# Groundwater Application Review Summary Form

Application # G- 19468

# PUBLIC INTEREST REVIEW FOR GROUNDWATER APPLICATIONS

TO: Water Rights Section Date 5/9/2025  
 FROM: Groundwater Section Travis Brown  
 Reviewer's Name  
 SUBJECT: Application G- 19468 Supersedes review of \_\_\_\_\_  
 Date of Review(s)

Hydrographs

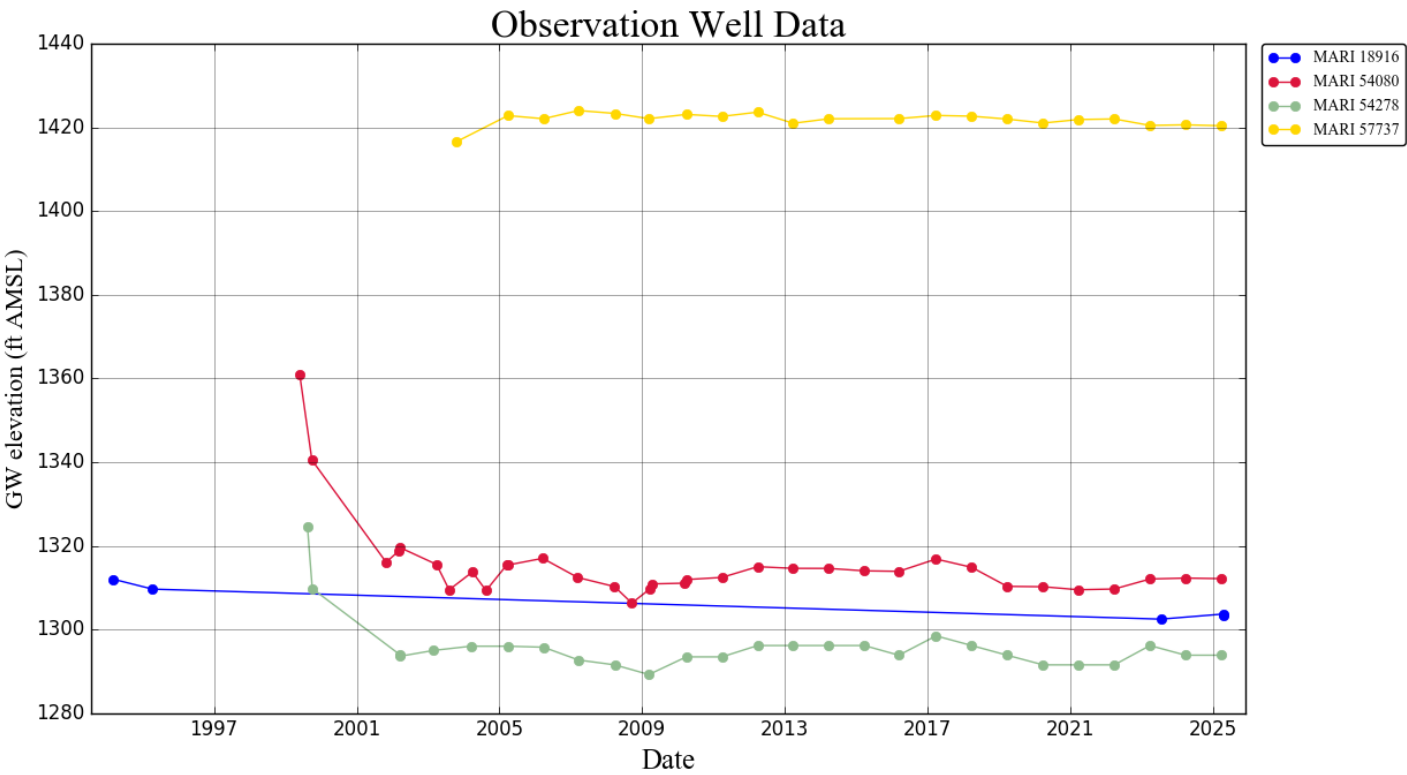
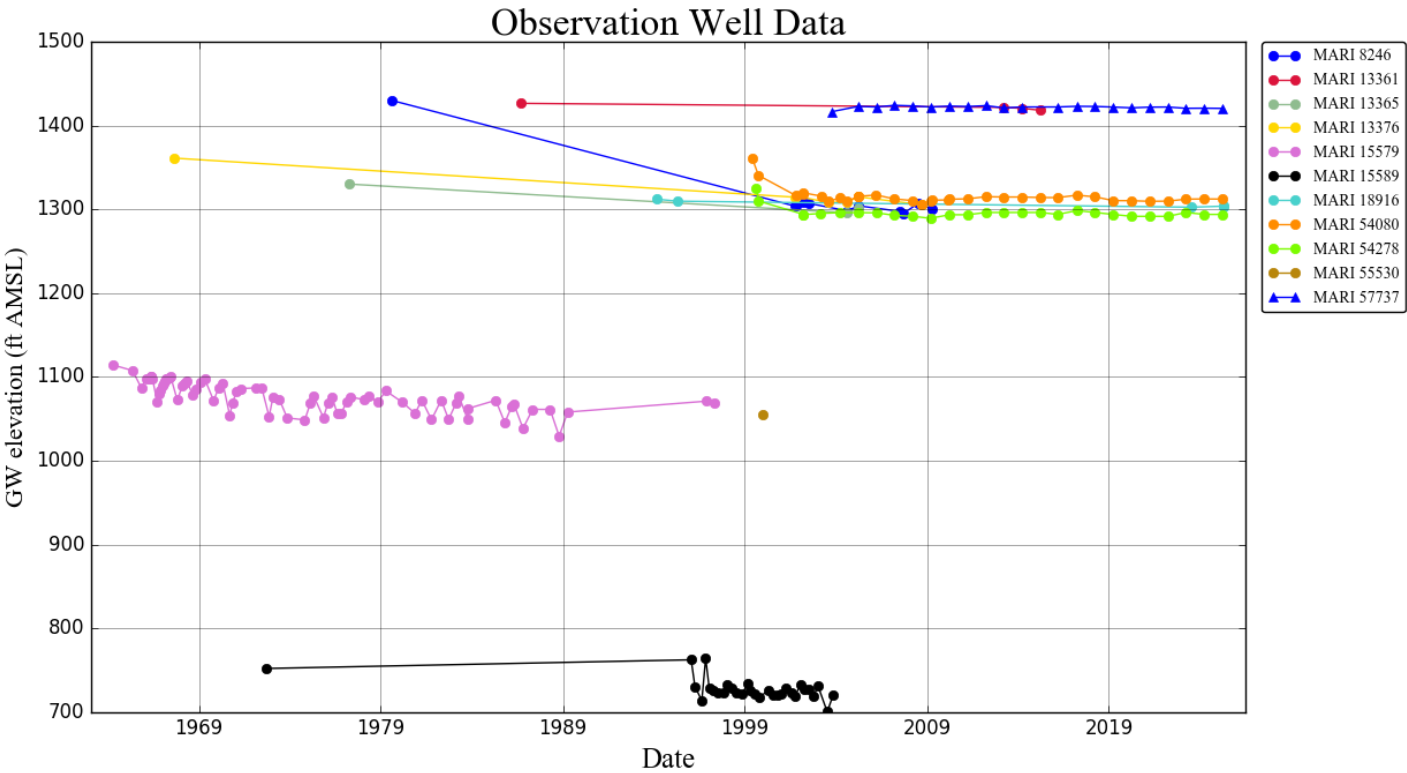
The closest well with any time series water level data is MARI 15579, ~2.5 miles to the southwest of the proposed POA. MARI 15579 exhibited an overall decline in water level of ~56 ft between 1965 and 1989 but showed ~11 ft of recovery between 1989 and 1997, although it was still down ~45 ft from its highest value in 1965; more recent data was not available. The nearest well with recent water level data is MARI 18916, ~2.9 miles northeast of the proposed POA, which has shown an overall decrease in water level of ~8.5 ft since it was drilled in 1994 (see attached Hydrographs). Wells further to the north with current data show relative stability from the early 2000s through 2025 (see attached Hydrographs). However, between 1999 and 2002, MARI 54080 showed an overall decline of ~42.3 ft from the water level reported on its well completion report in 1999. Similarly, between 1999 and 2002, MARI 54278 showed an overall decline of ~31.0 ft from the water level reported on its well completion report in 1999. This pattern of steep initial decline followed by subsequent stabilization may indicate these wells (MARI 54080 and MARI 54278) commingle multiple aquifers. **The preponderance of the current water level data indicates the proposed aquifer is not over appropriated.**
